WATER QUALITY MEMORANDUM

Utah Coal Regulatory Program

RE: 2006 Second Quarter Water Monitoring, Canyon Fuel Company, LLC,
Skyline Mine, C/007/0005-WQ06-2, Task ID #2551

Flow vs. Palmer Hydrologic Drought Index and Surface Water Supply Index
 CS-16

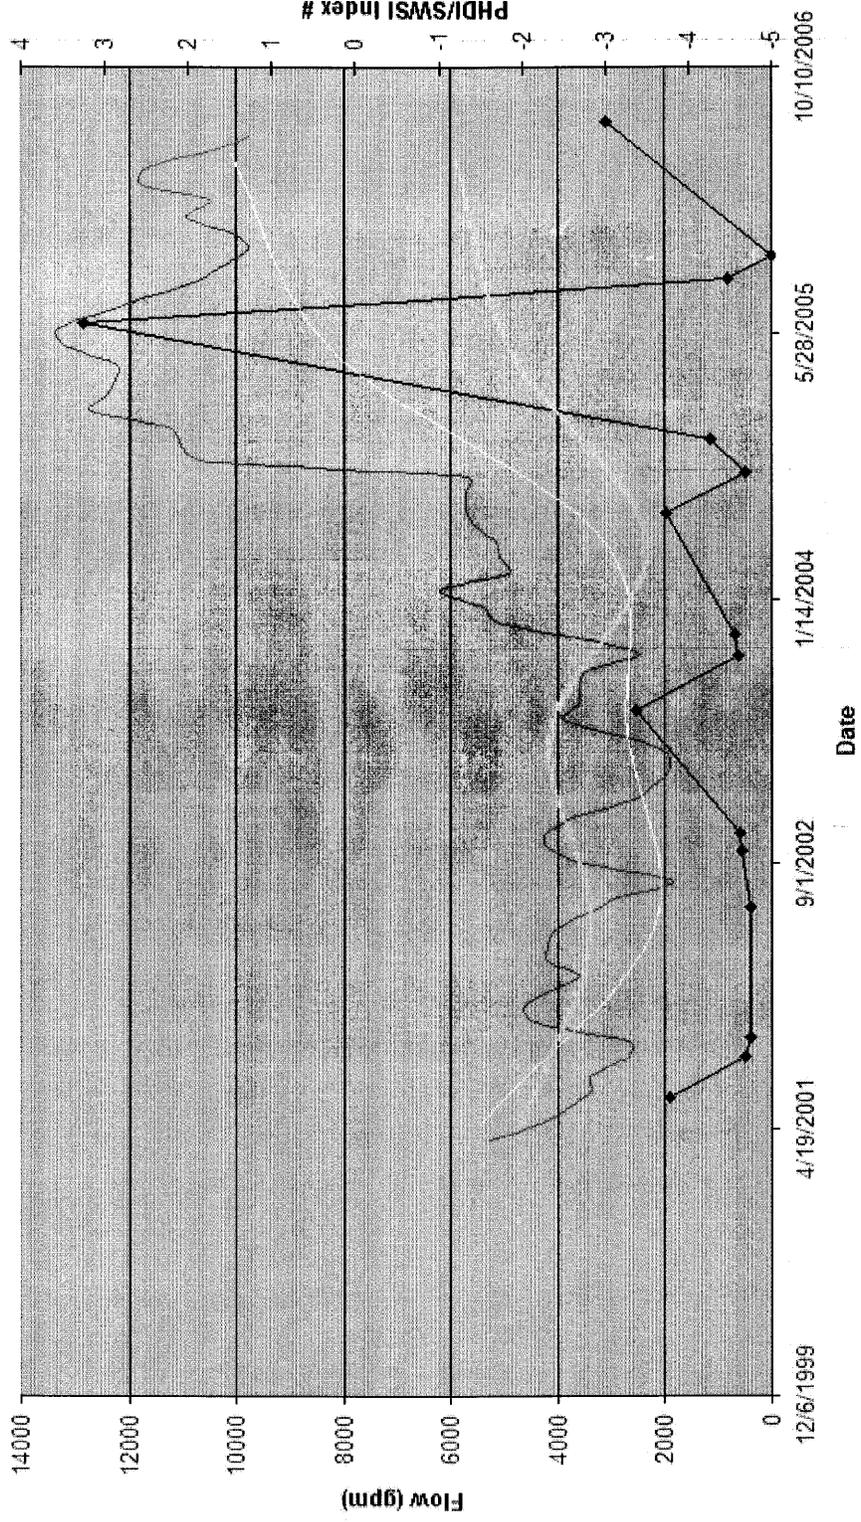
Flows were higher than average at CS-16, CS-18, F-9, WQ3-43, and WQ4-12. Monitoring of these sites began in 2001 or 2002. Both the Palmer Hydrologic Drought Index (PHDI) and Surface Water Supply Index (SWSI) show 2001-2004 as "dry" years, and there is an upswing during this quarter. Flows at all sites track well with the indexes.

Monthly Average Discharge to Electric Lake
ELD-1 (combination of all JC wells)

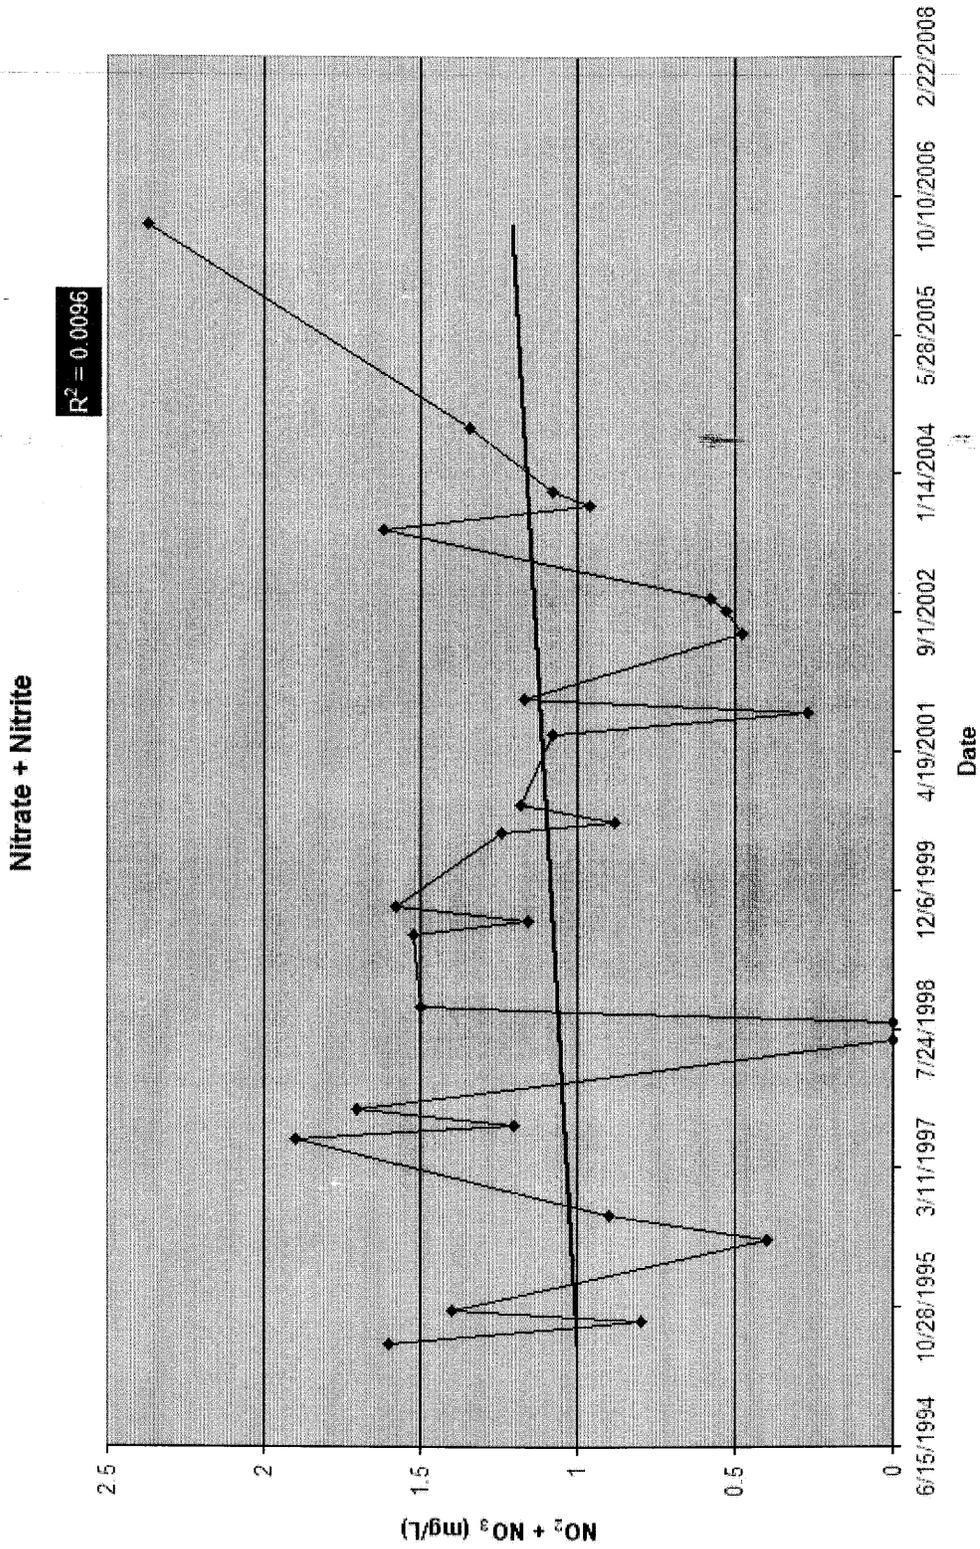
Discharge from JC-1 has been steady at around 4000 gpm since August of 2004. In August 2005, the monthly average dipped to below 2000 gpm when PacifiCorp shut the pump off for 15 days. The June average is just above 2000 gpm because the power line to the pump was being rebuilt, leaving no power to the pump for over a week. A steady discharge around 4000 gpm is projected for the foreseeable future, except in cases such as these.

Specific Conductivity

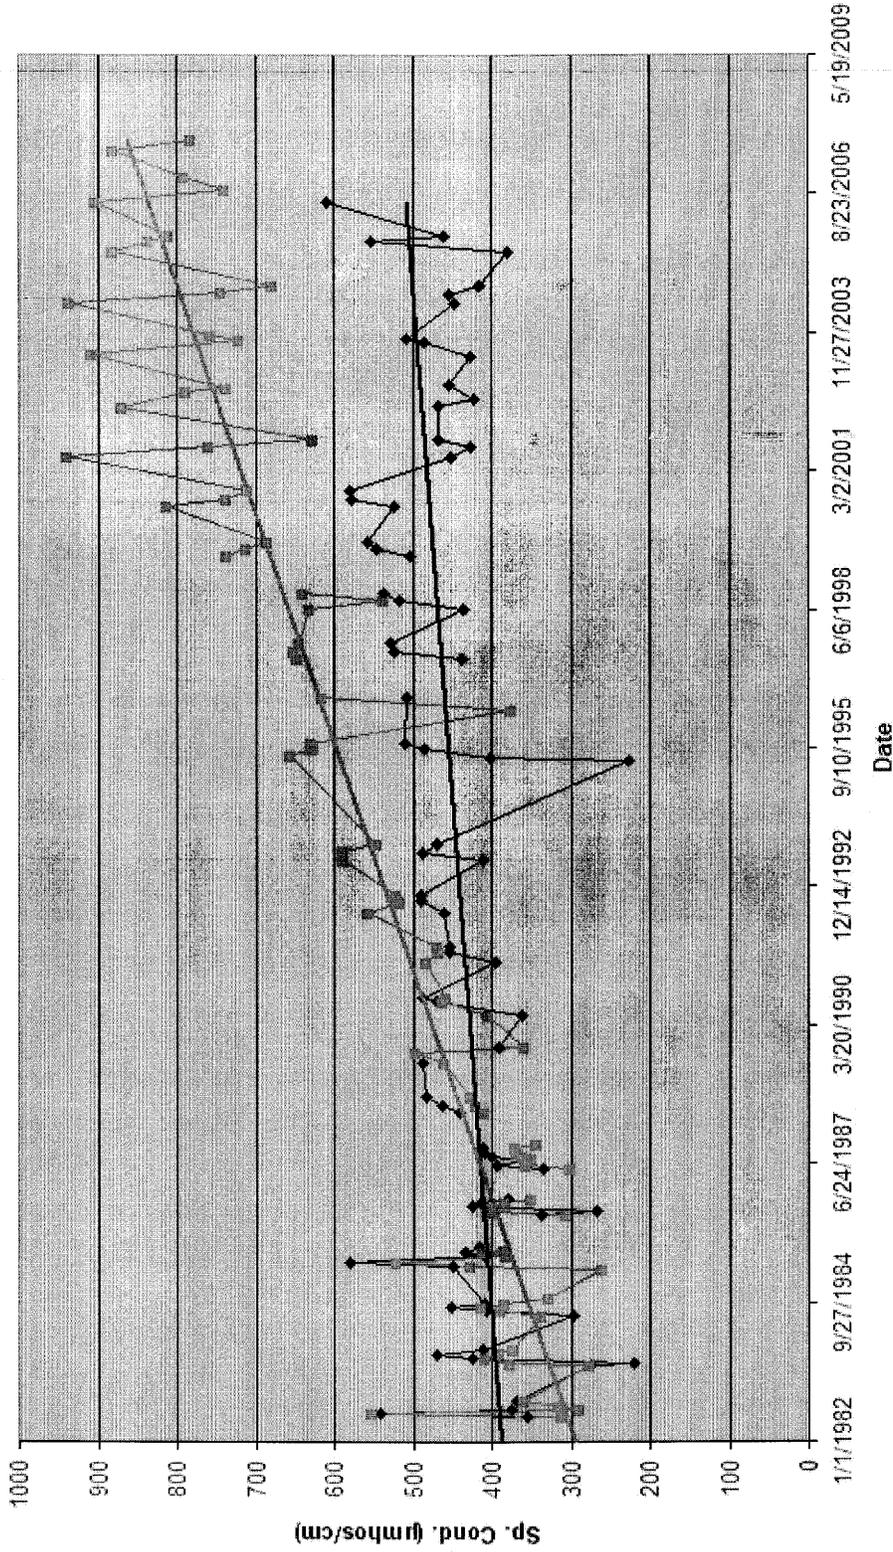
There is a strong upward trend in the specific conductivity at S22-5 ($R^2 = 0.851$), and a weak upward trend in the specific conductivity at S35-8 ($R^2 = 0.2236$). There is no standard for specific conductivity, but it is closely related to total dissolved solids (TDS). The TDS at each of these sites is within the expected range.
